SECTION 4.55(2) MODIFICATION APPLICATION

Building R4A, One Sydney Harbour, Barangaroo South, Sydney

Figure 1: Revised floor levels

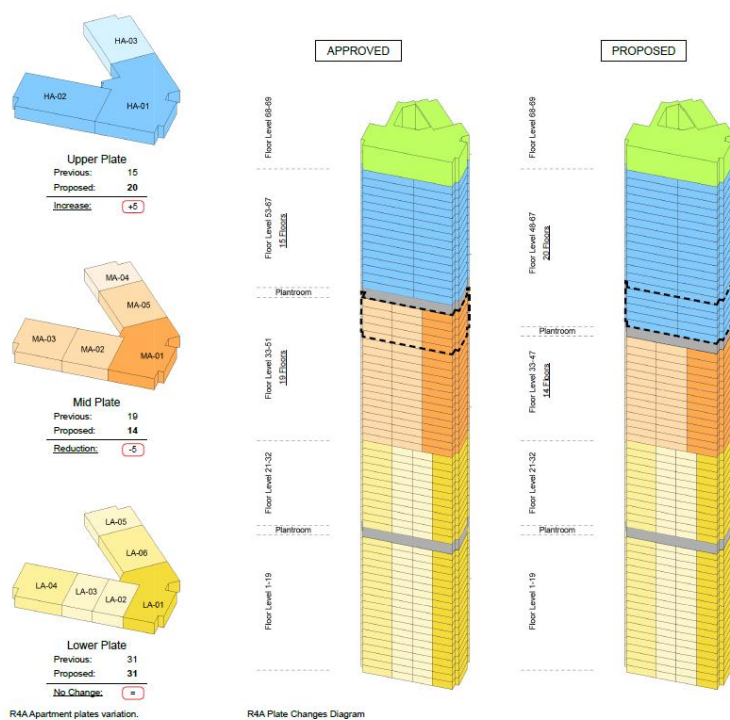
The modifications include changes in floor levels to correlate with the relocated plant room and allows for the levels of Building R4A to align with Building R4B¹. The revised levels are illustrated at **Figure 1** and **Figure 2**. The changes in floor levels are minor and will not change the overall height of the building, which remains at 250 metres.

Figure 3: Revised lower, mid and upper floorplate layout

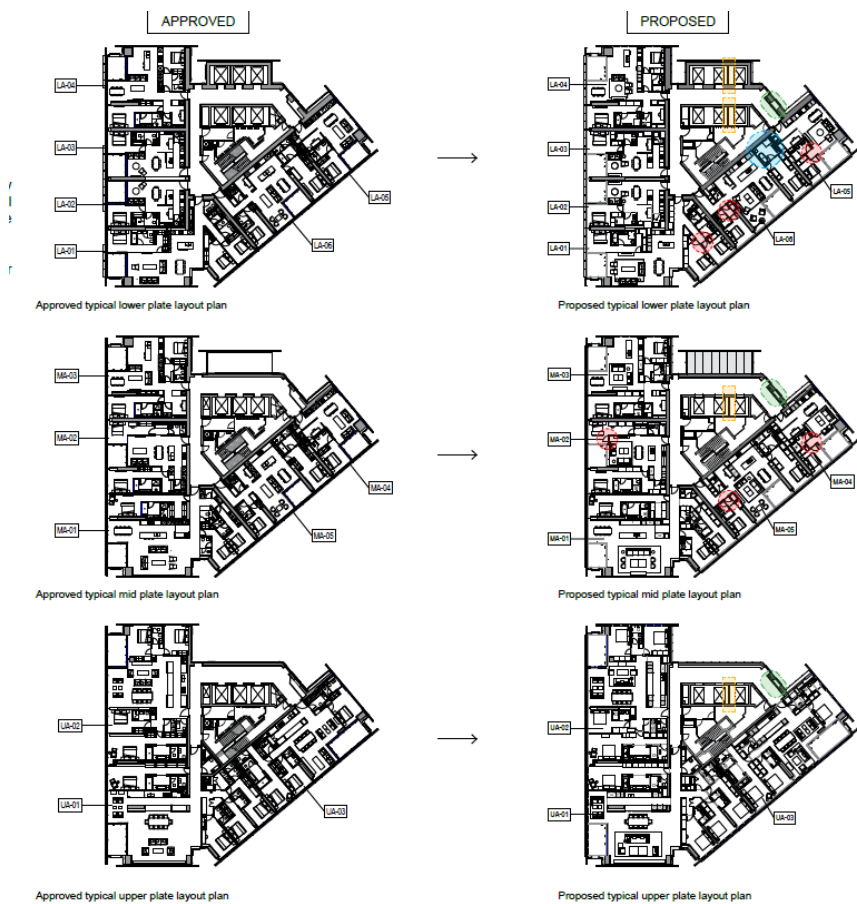
There are a number of internal layout adjustments to Building R4A that have arisen through design development and in response to the revised apartment mix, which are listed by level below. These changes are discussed in the Design Report at **Attachment B**. Changes to typical floor plates are illustrated at **Figure 3** and **Figure 4** below.

- Ground Floor: Lift lobby extended, gas metre room relocated, goods lift amended and amendments to mail room and retail area layout.
- Podium Level 1: Plant room layout updated, amendments to awnings, removal of windows.
- Podium Level 2: Bridge link access amended, terrace stairs and lift layout amended, pool access and layout amended and plant room layout amended as part of this modification.
- Lower Plate Level 1: Addition of canopies and awnings, balconies converted to wintergardens.
- Lower Plate Level 2-19: Balconies converted to wintergardens.

- Mid Plate Level 39-41: Low rise lift overrun added and changes to lift controller and motor room.
- Plant Level 47: Plant relocated from level 52 to level 47.
- Upper Plate Level 48-52: Mid plate levels converted to upper plate levels.
- Penthouse Level 68: Private lift lobby extended, wintergarden added.
- Penthouse Level 69: Wintergarden added, pool area amended and internal stairs removed.
- Roof Level 70: Steptype ladder added.

Figure 6 Extent of façade changes (new changes show in dashed line)

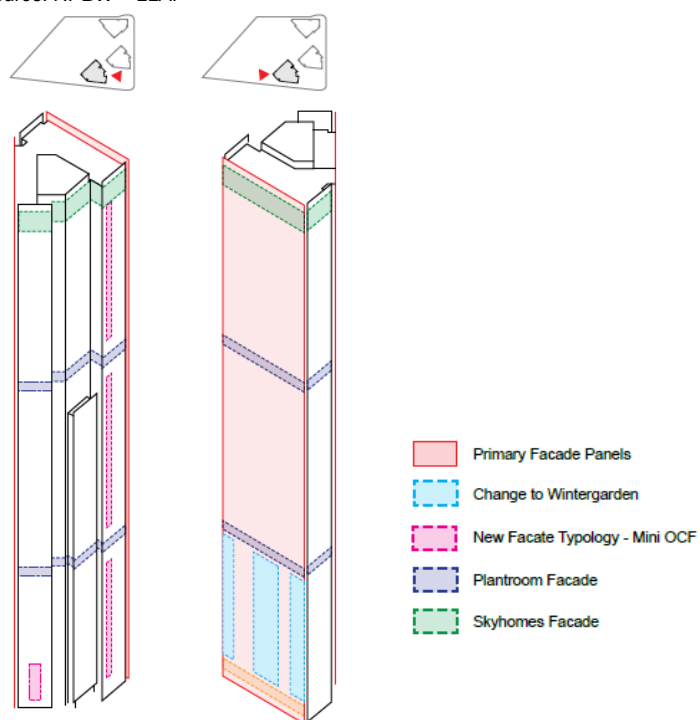
A number of alterations to the façade of the development are proposed to ensure wind, natural ventilation, open space and solar access requirements have been met, the extent of which are illustrated at **Figure 5** and **Figure 6**.

- Reconfiguration of primary façade panels is proposed, based on the results from wind reports. The previous wind deflectors were only present on some windows and had a larger extrusion and on further investigation resulted in an undesirable wind effects. The refined design proposed by this modification includes a smaller wind deflector on all windows, which provides both a unified façade design as well as improved wind results.
- Modifications to window types and façade design for bedrooms facing south-east are proposed. This allows for improved cross ventilation for the bedroom facing south-east on each floor. The modification will allow for the window to open inwards, to allow for adequate cross ventilation and therefore improved amenity.

- Changes to the podium façade are proposed to better respond to thermal requirements. It is proposed that the wintergarden sash window panels are replaced with the open cavity façade windows that comprise the majority of the building.

- Modifications to the plant room façade are proposed in order to better respond to the mechanical ventilation requirements for the plant room equipment. These changes include the removal of the glass panel that was located outside of the ventilated louvres, and the inclusion of two additional ventilated louvres on the southern and south-eastern elevation of the plant room floor.

- Change of Level 1-19 balconies to wintergardens, as discussed above. This change will improve comfort and amenity for residents, as well as ensuring consistency across the façade.

- The changes of the upper level from penthouse to skyhome results in façade changes due to the addition of several wintergardens to respond to the revised dwelling mix proposed. The façade changes will facilitate the addition of these wintergardens.
